NO. PMA 84-06

TITLE: FAILURE ANALYSIS, F010 AND F011 VALVES, CLINTON PROJECT

Date: December 3, 1985

Failure Analysis Report of F010 and F011  
Valves From The Clinton Reactor

DDR No. L11-5503 Rev. 1  
 SHEET 4 OF 5

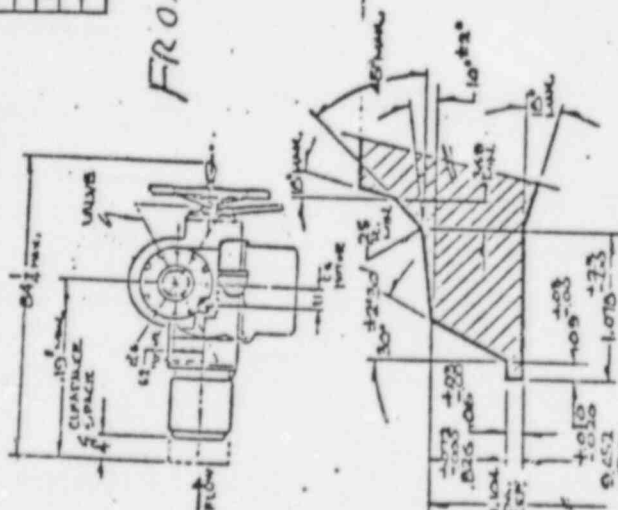
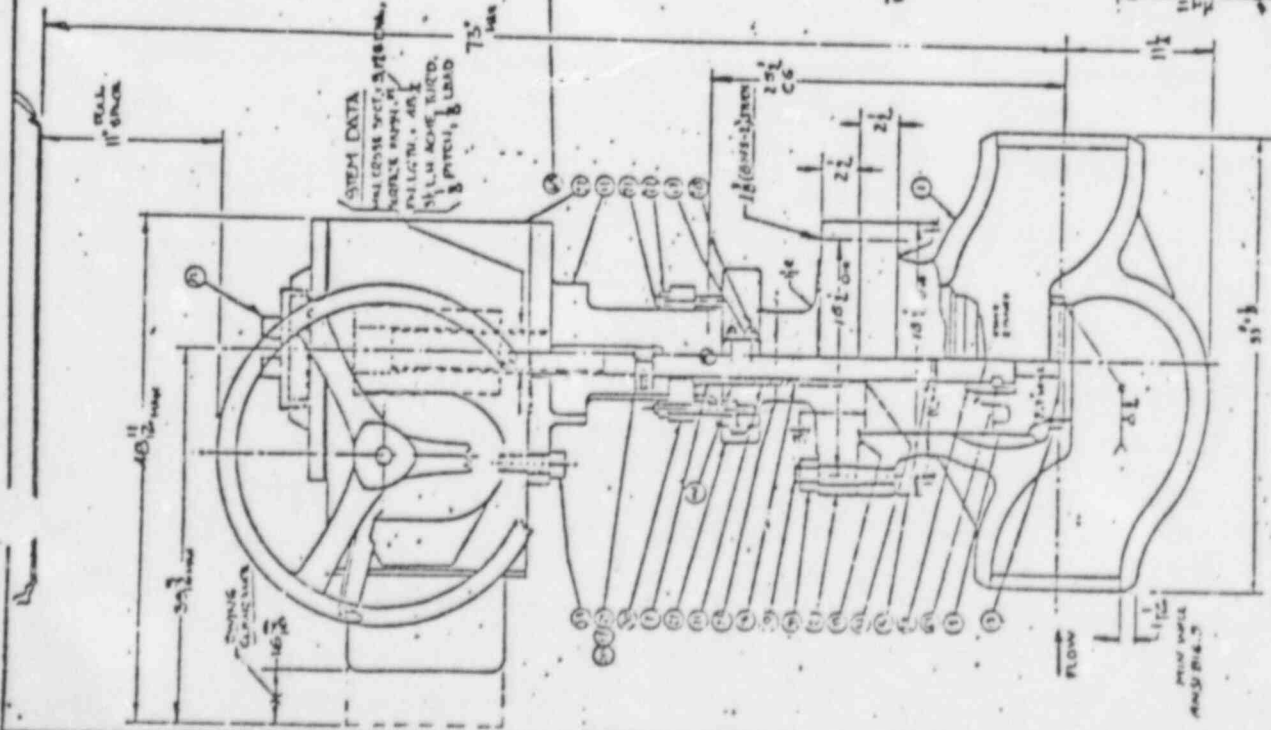
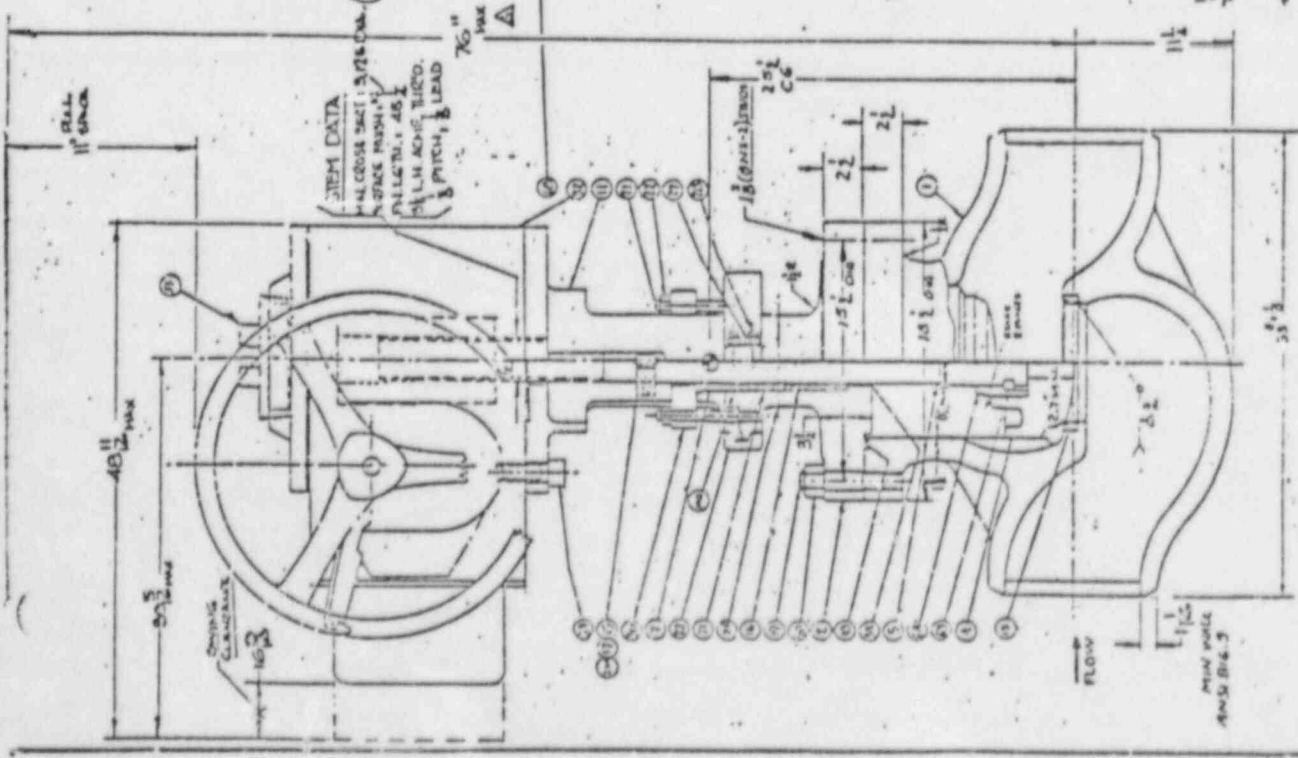
Review and approval is requested of Anchor/Darling Drawing 2999-3 Rev.(J) for application to Clinton valve E22-F011.

Anchor/Darling Drawing 2999-3 Rev. (J) depicting a modified bonnet to accept a drop in backseat is approved for valve E22-F011 at Clinton Station, Sheet 4 of this FDDR.

General Electric to incorporate Anchor/Darling Drawing 2999-3 Rev. (J) into the vendor print file for valve E22-F011 at Clinton Station.

FDOR NO. L41-5503 Rev. 3  
SHEET 4 OF 7

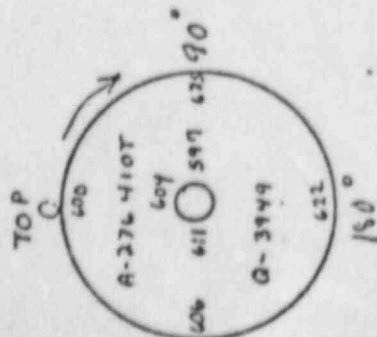
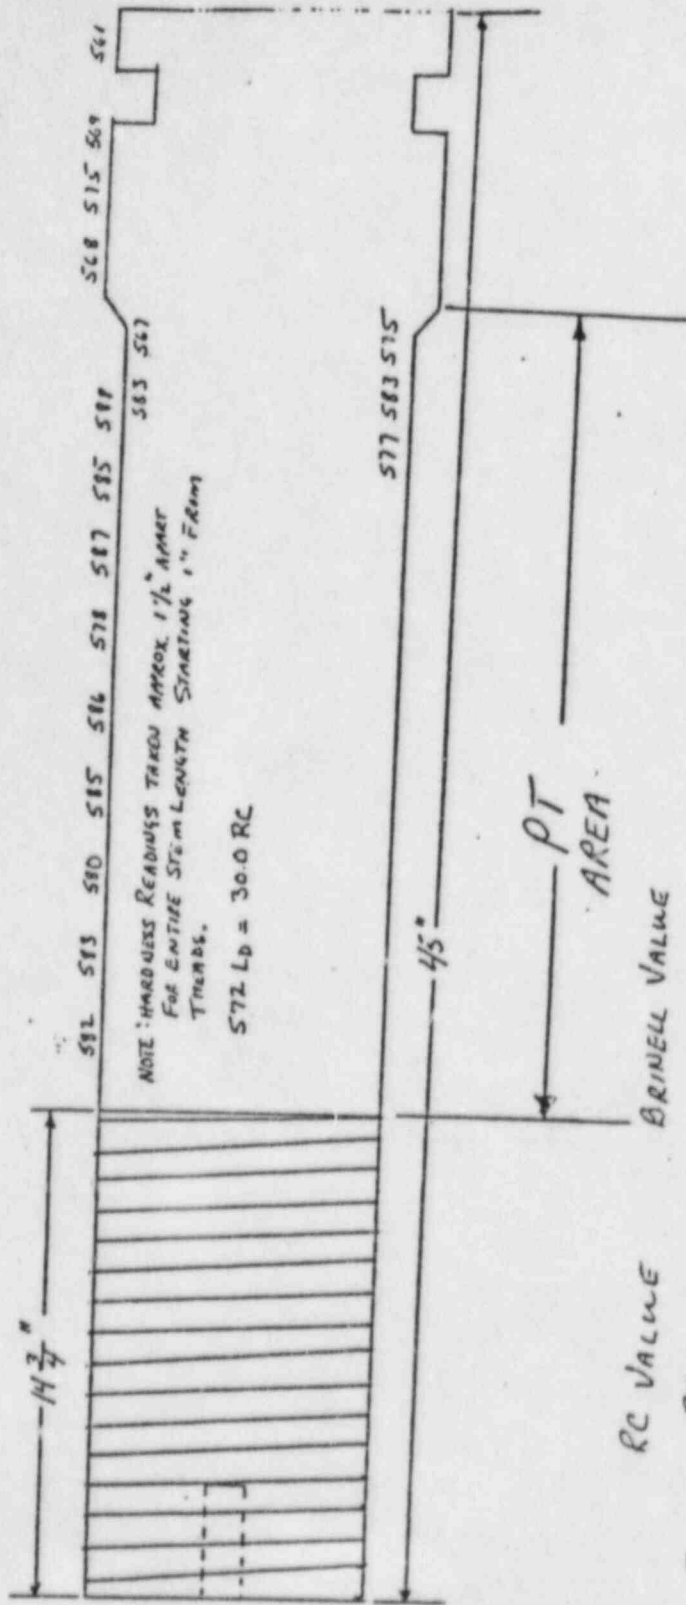
- a) I.P. Co. has requested approval to use packing gland parts and stem clamp parts from the spare "Black Fox" valve, and to install new disc and disc nut.
- b) Actual hardness test data of the new valve stem supplied by I.P. Co. is documented on sheet 4 of this FDDR. Hardness exceeds Brinell 300 in some places.

The water-wetted surfaces of the IP Co. - supplied valve stem have hardness less than or just slightly above Brinell 300; this indicates an acceptable condition of heat treat of the stem in the area of concern.
